ARM Group Inc.

Re: Response to Completeness
Deficiency
Permit No. GP05020718-002
ET - Braddock Well Pad & Pipelines
Merrion Oil & Gas
East Pittsburgh Borough, North
Braddock Borough, North Versailles
Township
Allegheny County, PA
ARM Project 180549-1-1

To: Ryan Davis, Operations Manager, Merrion Oil & Gas
From: Brian Bonner, P.E., Project Manager
Date: October 23, 2018
Re: Proposed ET Braddock Well Pad and Pipelines - Summary of Hydrologic and Hydraulic Analysis

Culvert Report

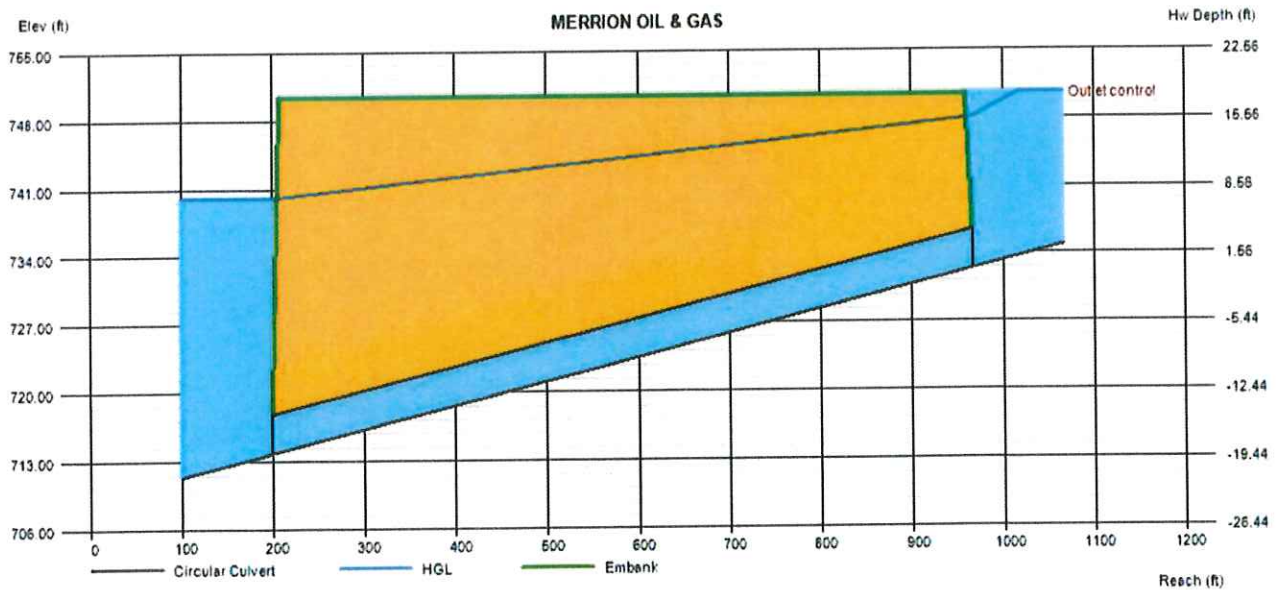
Comment 2: Aerial Stream crossings in urban areas need to be elevated above the 100 year storm event. Provide Hydrologic and Hydraulic Calculations for the 100-year storm event for the stream enclosure. The calculations should be affixed with

Response: The Hydrologic and Hydraulic calculations for the 100-year storm event, sealed by a registered professional engineer, are provided in the enclosed H&H analysis summary. A sealed certification statement is also contained within the memorandum.
